Re: NEW PLANS (MOD 9) FOR BARANGAROO CENTRAL

Barangaroo Concept Plan (Mod 9)

National Trust submission relating to Barangaroo Concept Plan (Modification 9)

Figure 14: Proposed envelope with RLs. (Source: *Central Barangaroo Urban Design Report and Design Guidelines*, prepared by SJB, 28 November 2023).

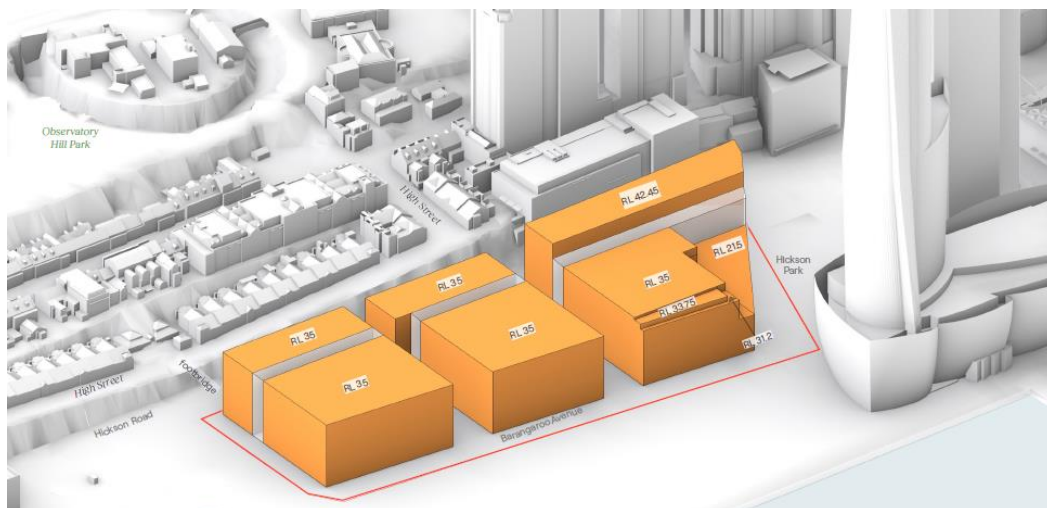
The 2024 Urban Design Report proposes a building envelope that varies in height from RL 21.5 to RL 42.45, as illustrated in Figure 14 below.

Further, the proposed building envelope will have catastrophic impacts on views from the Langham Hotel. The 'rise and fall' of the approved Concept Plan preserved east-west view corridors through the site. The proposed envelope would instead remove all harbour views and severely degrade the amenity of the Langham Hotel and its tourism offering. An analysis comparing the visual impact of both the approved and proposed building envelopes for Central Barangaroo is outlined in Figure 15 - Figure 20.

Figure 3 – Amended elevations overlaid with Mod 8 (approved concept plan) envelope and Mod 9 envelopes. 30 The Bond sits immediately to the rear of Block 5. The height exceedance objected to is outlined in red.

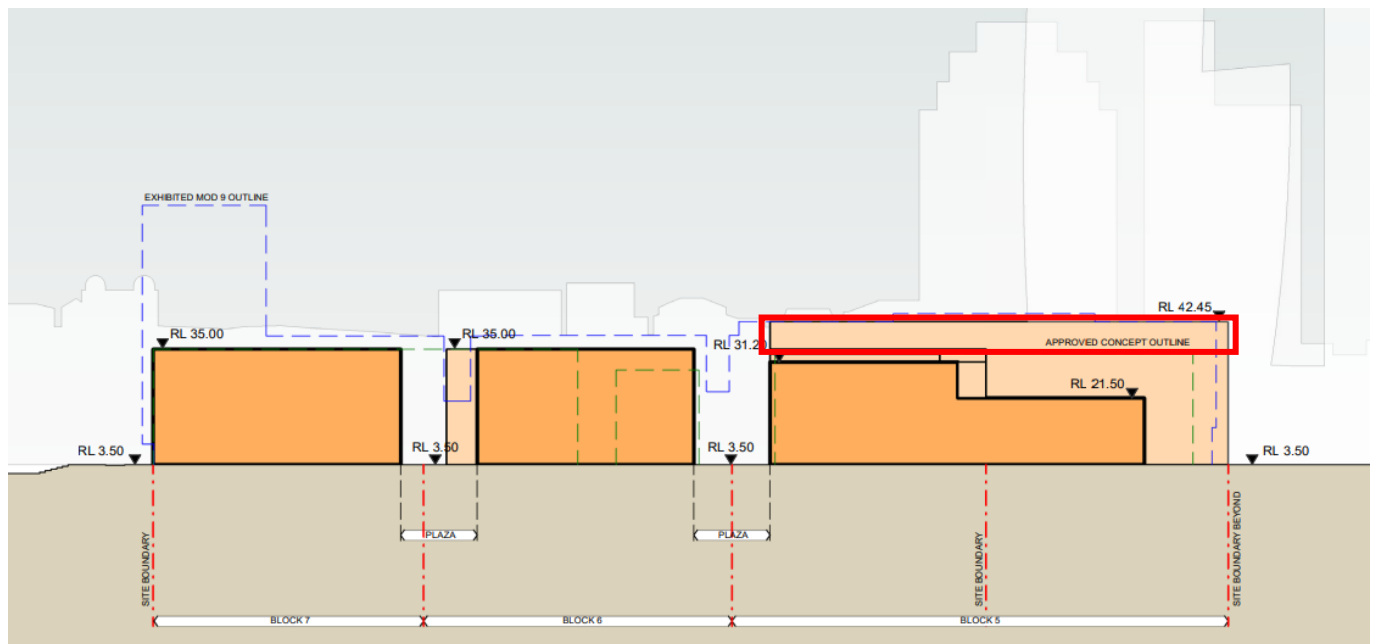
Visual impact and tenant amenity

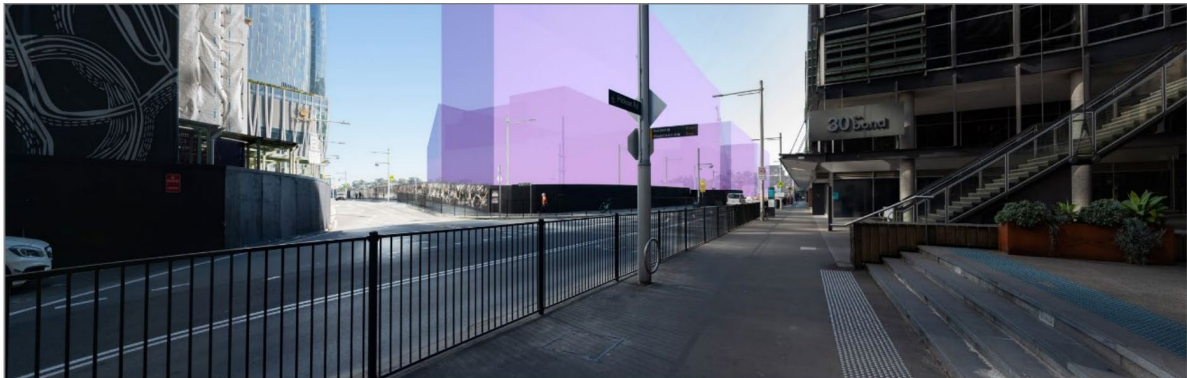
- It is easy to infer that this is all buildings on the southern edge of Block 5. However, only one building (Building 1B of Figure 46) is illustrated as changed (see Figure 41 reproduced below). This creates the extensive shadow seen in Table 23 10am assessment (reproduced in part below, note that at 9am the entire park is in shadow).

This shows the requirement for the southern boundary of Central Barangaroo to remain as per the 2016 (current) location, and for the need for the southern most buildings of Central Barangaroo to be stepped/terraced so as to eliminate shadowing of the parkland.

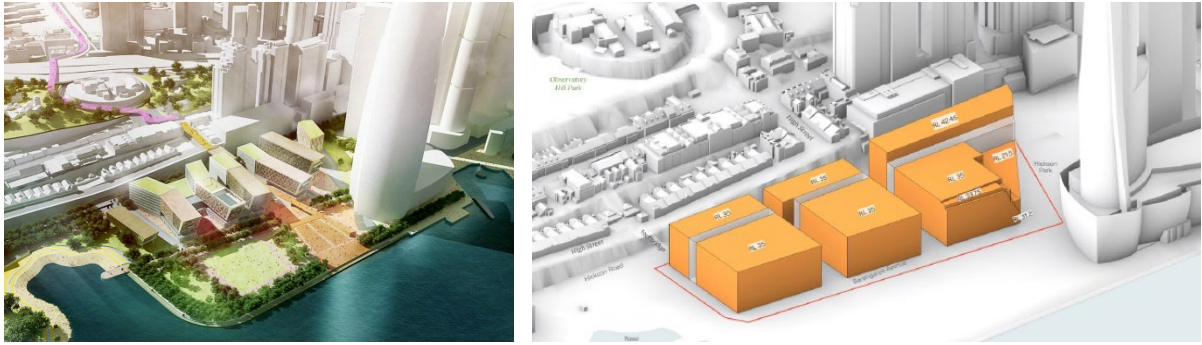
The SOM/AHH design team was replaced by Hassell in 2020. The 'bar code' configuration was abandoned in Hassell's scheme for the MOD 9 application lodged with the Department of Planning in July 2022. A massive 'perimeter block' configuration was proposed instead, dominating the Millers Point conservation areas and blocking significant views to and from Observatory Hill.

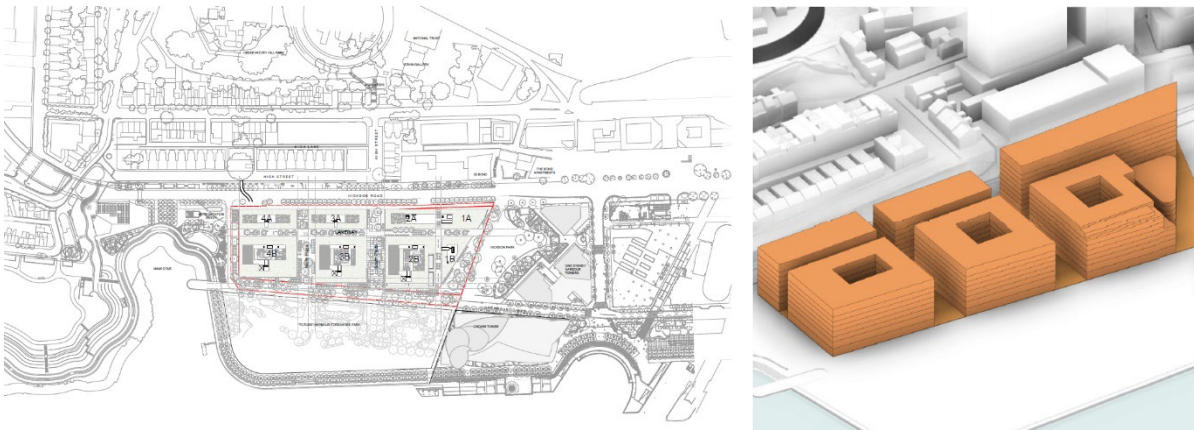
The current 'Response to Submissions' scheme, prepared by SJB Architects, has removed the Chipperfield tower, and reduced other building heights by 2.05 and 3.7 metres. The scheme, however, retains the bulky, view-blocking 'perimeter block' configuration rather than reverting to the 'bar code' configuration. Compared to the currently approved Concept Plan for Blocks 5, 6 & 7, Barangaroo Central (MP 06_01682 MOD 3, approved 11 November 2009, and MOD 8, approved 28 June 2016), the maximum height of Block 5 at RL42.5 is 8.45m higher; Block 6 at RL35m is 6m higher; Block 5 at RL35 remains the same.³
